Village of Shelby Planning Commission
Tuesday, November 17, 2020
Regular Scheduled Meeting– 6:30 P.M.

Subject: Review of Shelby Trails Site Plan Review, 220 Walnut Street

Re: 220 Walnut, Shelby, MI
Site Plan Review

SHELBY TRAILS APARTMENTS
220 WALNUT STREET
SHELBY, MICHIGAN

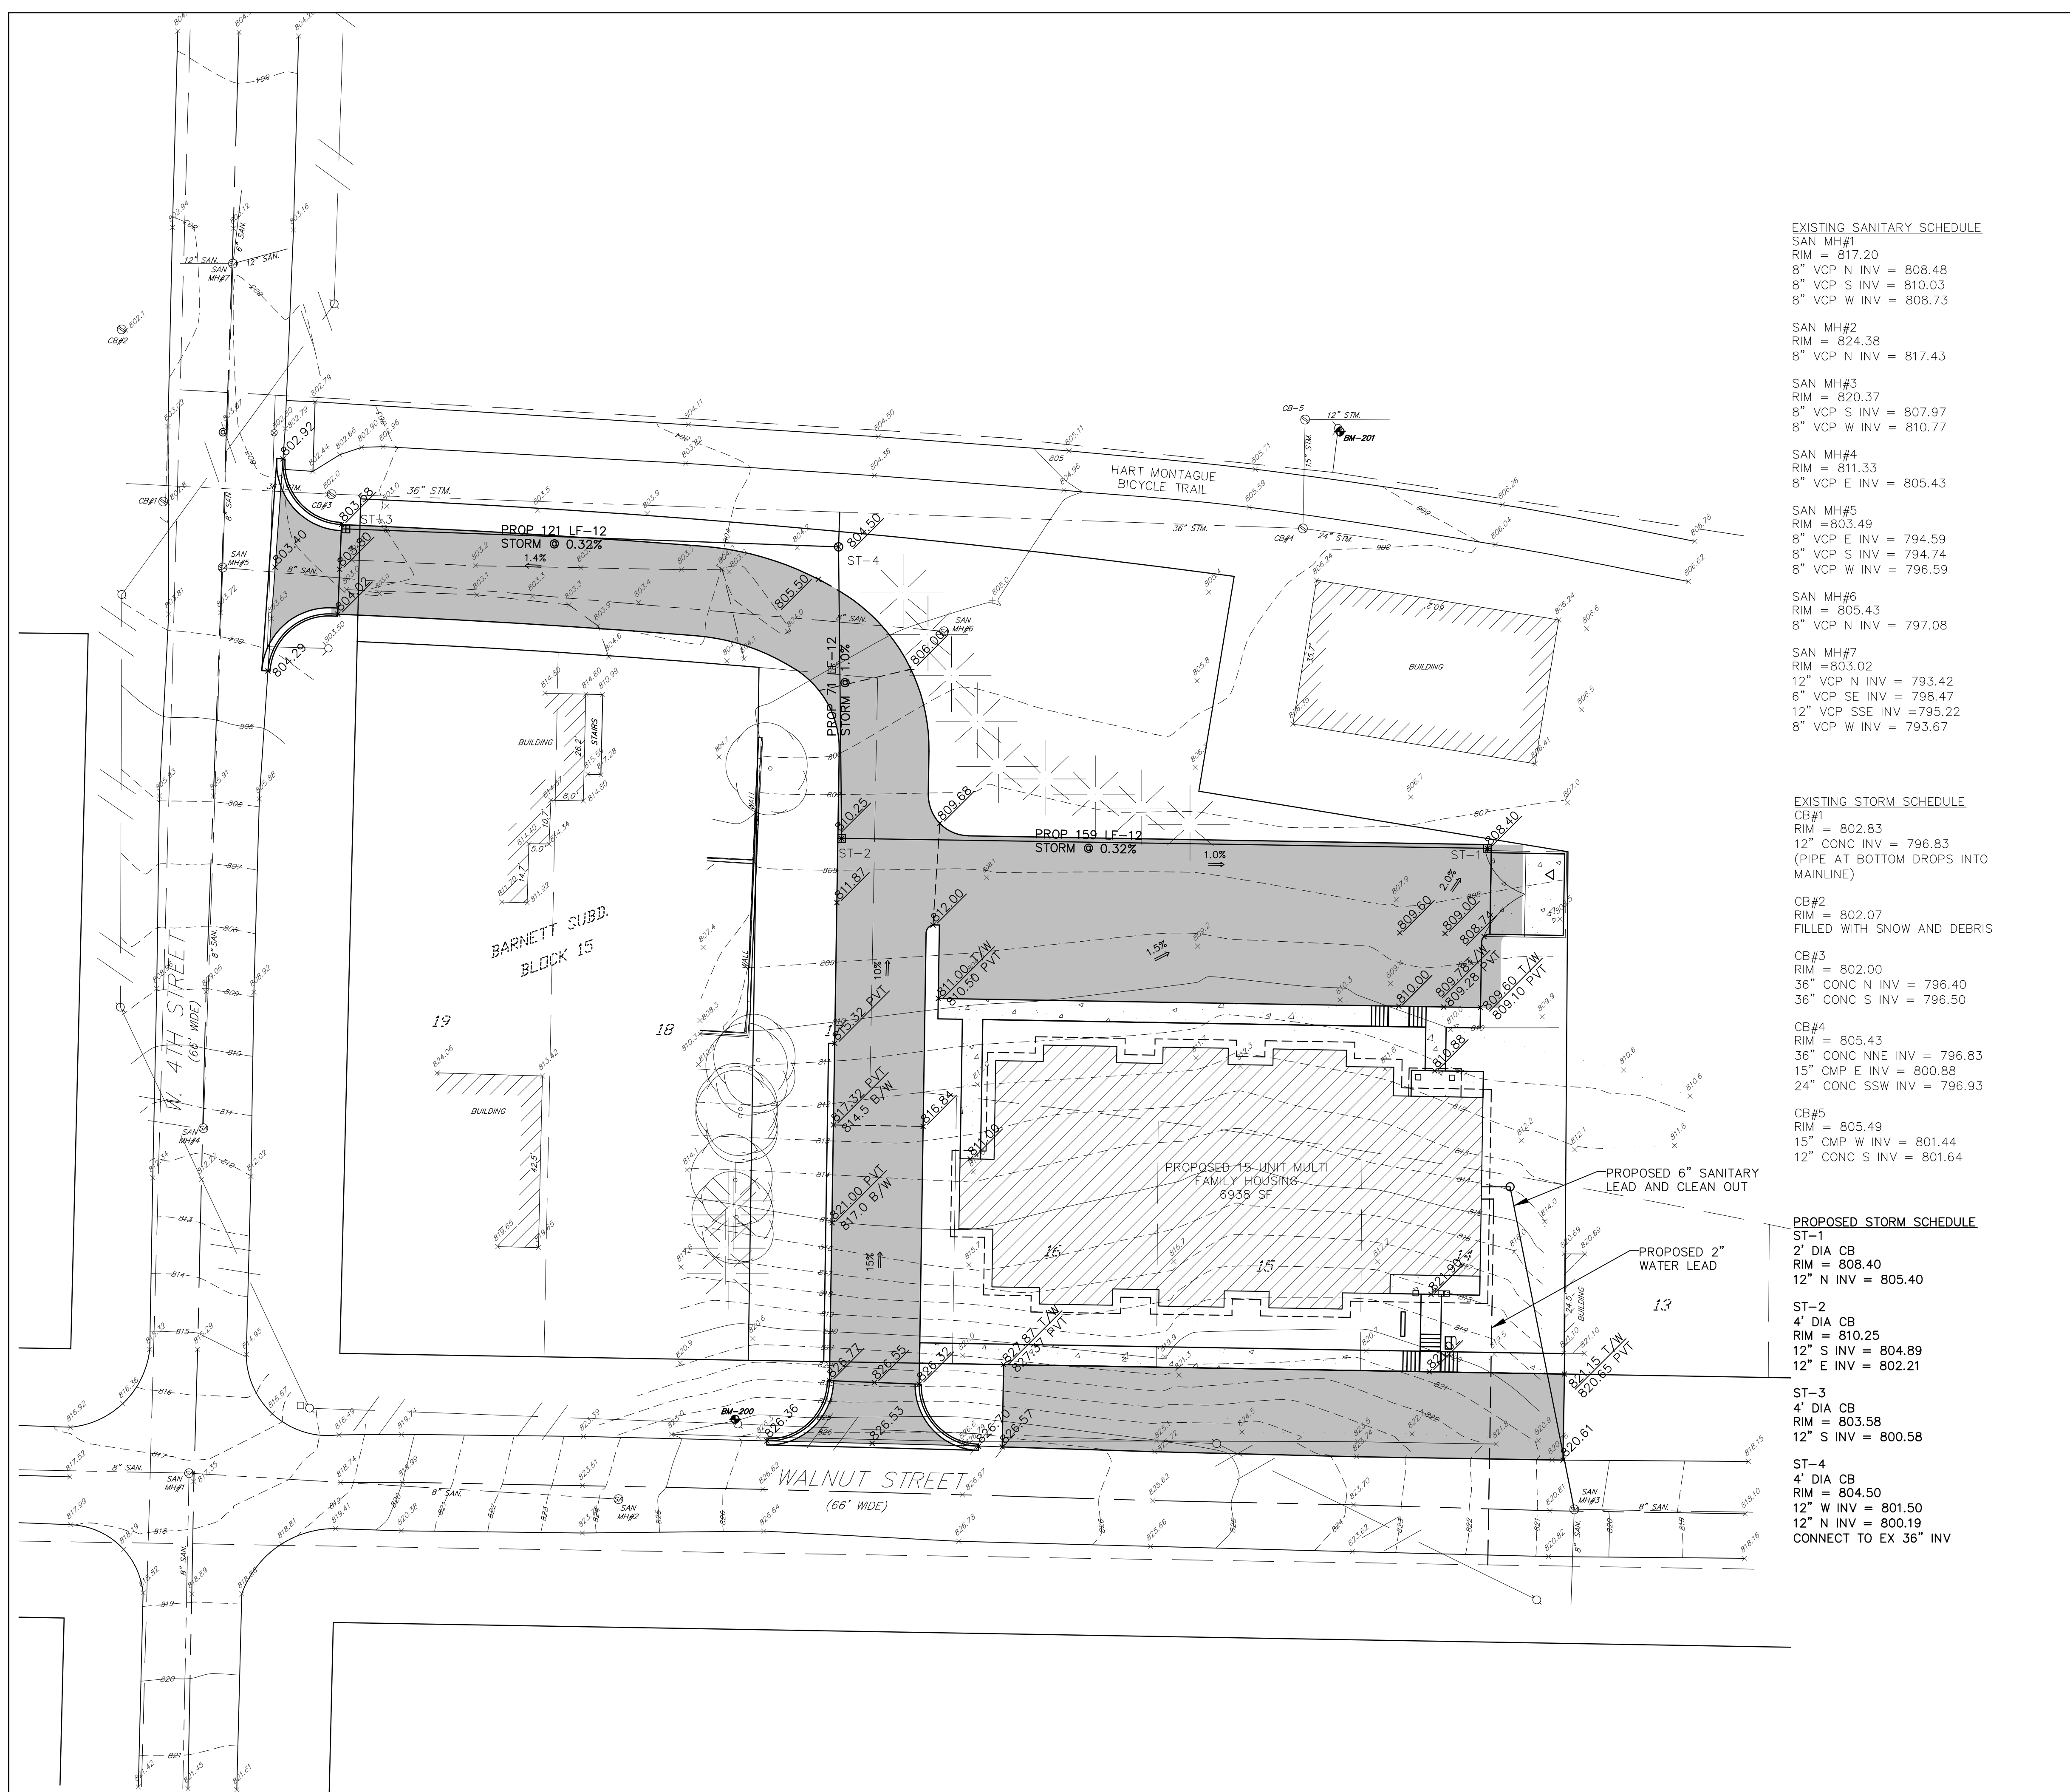
3. More parking and driveway requirements - Section 13.02 of the zoning ordinance requires that maneuvering lanes be a minimum of 24' wide (22' is shown).

- c. Adjacent zoning is shown as C-1 (sheet c-101). Zoning to the West is R-2.
 - d. Show all buildings, parking and driveways within 100' of the subject property (missing on the west side of Walnut).

4. (12.06.C.1.a) The building has two access driveways. Only one is allowed. This will reduce the amount of impervious surface on the property. Also, by eliminating the driveway off Walnut will eliminate the severely steep drive into the complex.

8. Parking. (13.02) We discussed this a few times and it was determined that the lesser of the apartment off-street parking requirements would be used for this project (1.5 vs. 2.5 spaces per apartment. The total parking required for this proposal is 1.5 per apartment x 15 apartments + 1 for the office = 23. The plan (c101) shows 23 spaces, but only 14 meet the off-street parking requirement (13.02.A.4). The parking on Walnut is not off street (therefore not allowed). Additionally, the Village does not allow any on-street parking from 2am – 6am from November 15 – April 1 for snow plowing. For both reasons above, the parking shown along Walnut must be removed from the plans. The parking lot along the east side of the building could be expanded to the north to create additional spaces.

9. (13.02.E.3) The driveway and maneuvering lanes in the parking lot must be 24' wide to accept two-way travel (shown at 22').
10. Miscellaneous –
 - a. You verified (by email) that there will be one water meter for the building.
